## PROJECT DESCRIPTION: Proposal

<b>PROJECT DATA TABLE</b>				
<b>Westech Village Center 8-05022</b>		<b>Permitted/Reqd</b>	<b>Permitted/Reqd</b>	<b>Proposed</b>
<b>Development Standard</b>	<b>Total Areas</b>	<b>I-1 Zone</b>	<b>Overlay Zone</b>	<b>Site Plan 8-05022</b>
<b>Gross Lot Area: Lot 38</b>	8.54 ac.	NA	NA	8.54 ac [371,902 sf]
Lot Area RE-2 Zone	0.35 ac.	NA	NA	0.35 ac [15,393 sf]
Lot Area I-1 Zone	8.19 ac.	NA	NA	8.19 ac [356,509 sf]
<b>Net Lot Area Lot 38</b>	8.54 ac.	NA	NA	8.54 ac [371,902 sf]
<b>Floor Area Ratio</b>	0.12 FAR		0.12 FAR	
<b>Gross Floor Area</b>	44,000 sf			44,000 sf
Retail - Bank	3,700 sf			3,700 sf
Retail - Restaurant <sup>1</sup>	24,000 sf			24,000 sf
Casual Retail - Restaurant <sup>1</sup>	8,500 sf			8,500 sf
Casual Retail - Retail	6,500 sf			6,500 sf
<b>Total FAR sf</b>	No Maximum		LATR Analysis	10,200 sf
<b>Density</b>				
Retail commercial	Base Zone (I-1)		50,000 sf max. <sup>1</sup>	LATR Analysis, p. 17
Retail commercial	Single Lot		15,000 sf max. <sup>1</sup>	Not to Exceed 15,000 sf <sup>1</sup>

Site Plan 8-05022 proposes a restaurants/retail development within the Cherry Hill US 29 Employment Area. The property is zoned I-1 and lies with the US 29

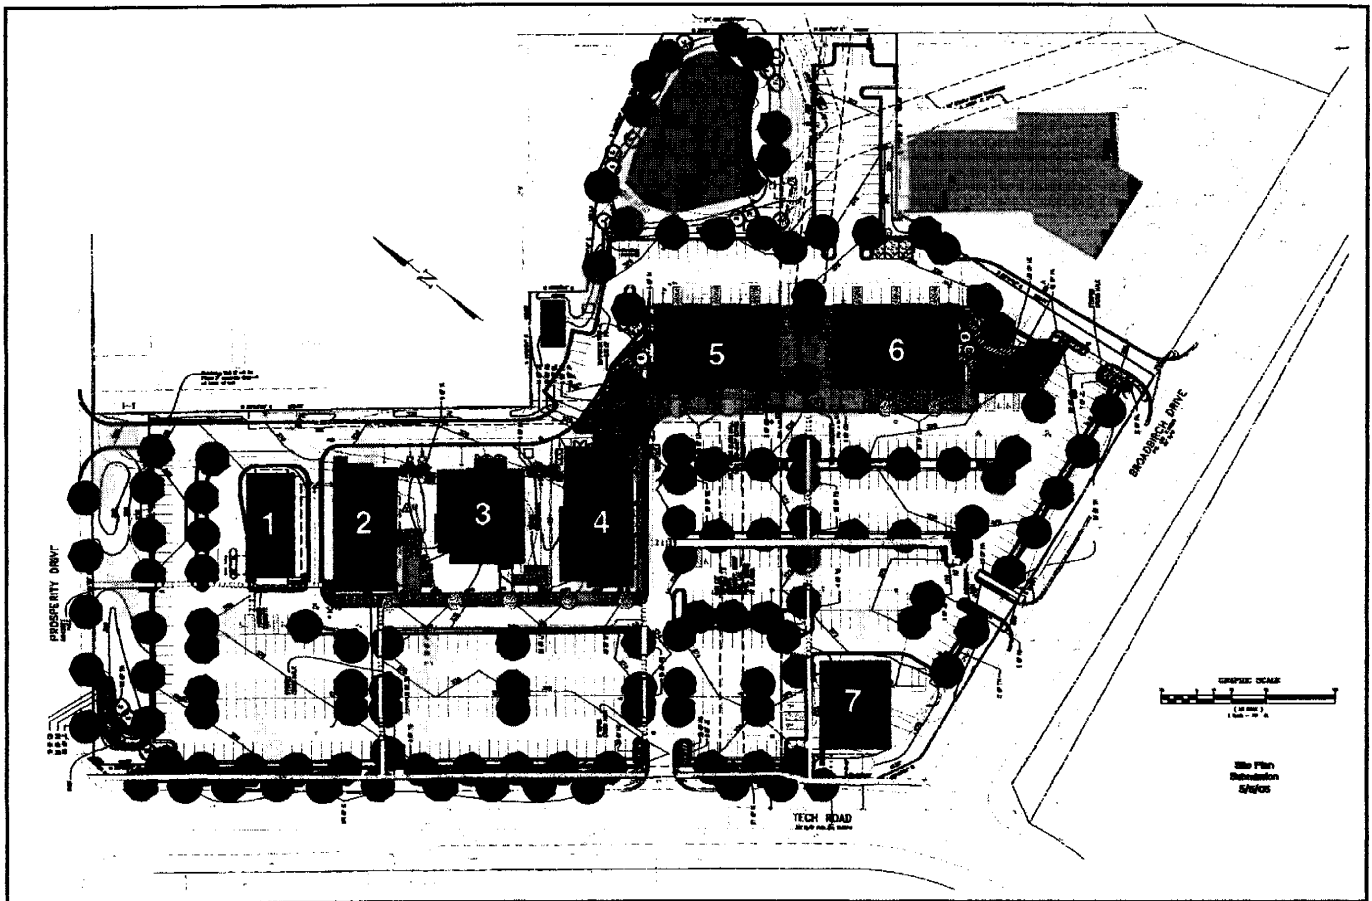
The open spaces that serve as little “plazas” between the restaurant and retail buildings offer an opportunity for creative landscape design in defining public spaces. Staff encourages the applicant to enhance these spaces, in area, materials, lighting and seating, as a means to articulate a better public realm of the development and marketability of the businesses.

The larger plaza public area between Building 5 and Building 6 is optimally placed to serve the Casual Restaurant and Retail proposed, that is, the potential sandwich shops and lunch services expected.

Pedestrian circulation is adequate, safe and efficient. The pedestrian circulation proposed essentially follows the lines of shade trees that give the pedestrian directional cues—enhancing safety and efficiency of the pedestrian routing. Staff recommends that the crosswalks across all the drive aisles be striped and painted according to Best Practice techniques.
